**Noise Symptom - Noises From Around the Steering Shaft: Replacing intermediate steering shaft (SY 17/14)**

Revision: This bulletin replaces bulletin, Group 4, #17/14, dated August 23, 2017.

Model Line: **Macan**

Subject: **Intermediate steering shaft**

*Position of the spray nozzle at the steering shaft duct at the engine compartment side*

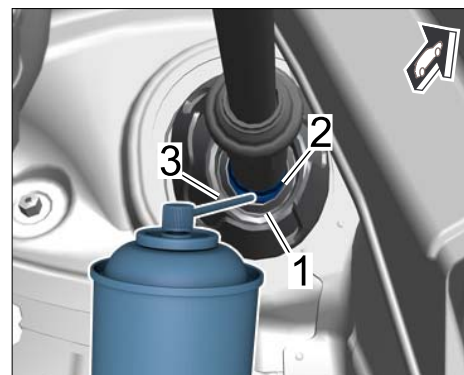
- 2 Carefully pull the rubber on the steering shaft duct (⇒ *Position of the spray nozzle at the steering shaft duct at the engine compartment side -item 1-*) away from the steering shaft in order to access the blue friction ring (⇒ *Position of the spray nozzle at the steering shaft duct at the engine compartment side -item 2-*).

- 3 Push the spray nozzle (⇒ *Position of the spray nozzle at the steering shaft duct at the engine compartment side -item 3-*) under the sealing lip as far as the blue friction ring (⇒ *Position of the spray nozzle at the steering shaft duct at the engine compartment side -item 2-*).

- 4 Spray the top and bottom.
- 5 For optimal distribution of the lubricant, turn the steering fully to the left and right several times immediately after spraying and also change the fore-and-aft adjustment position as far as it will go.

*Figure 1 — On the left is the passenger compartment side and on the right is the engine compartment side.*

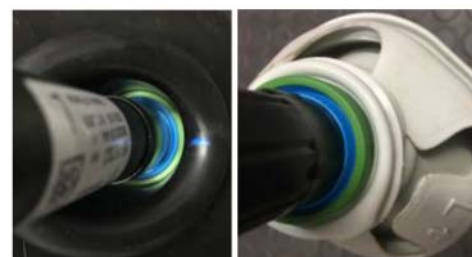
- The steering shaft has two blue rings that need to be lubricated individually (Figure 1). Lubricant can't effectively flow from one to another.
- Each ring needs to be lubricated while the shaft is held vertically.
- This means the shaft has to be removed from the vehicle.
- The top ring is lubricated, and then the shaft is turned over and the other ring is lubricated.

Figure 2

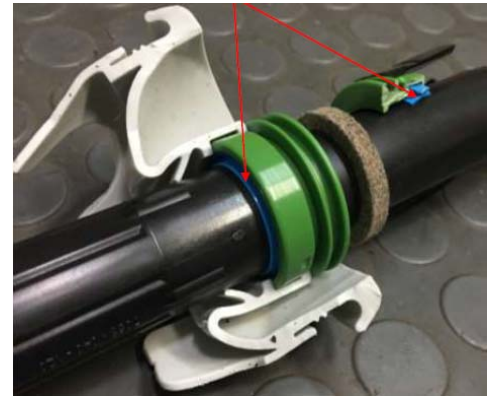
**Two rings** can be seen in the assembly view on Figure 2.

Both rings are identical, the passenger compartment ring is cut away for clarity. Notice the felt insulator between them.

Figure 3

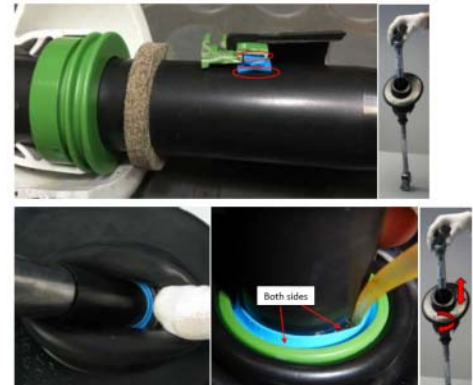
Lubricate the blue ring at its contact surfaces with the shaft and with the green ring (Figure 3).

Lubricate the blue ring on both contact areas (it doesn't take much). Move the large bulkhead seal up and down. Rotate the seal around the shaft to distribute the lubricant. Flip the shaft over and repeat for the other blue ring.
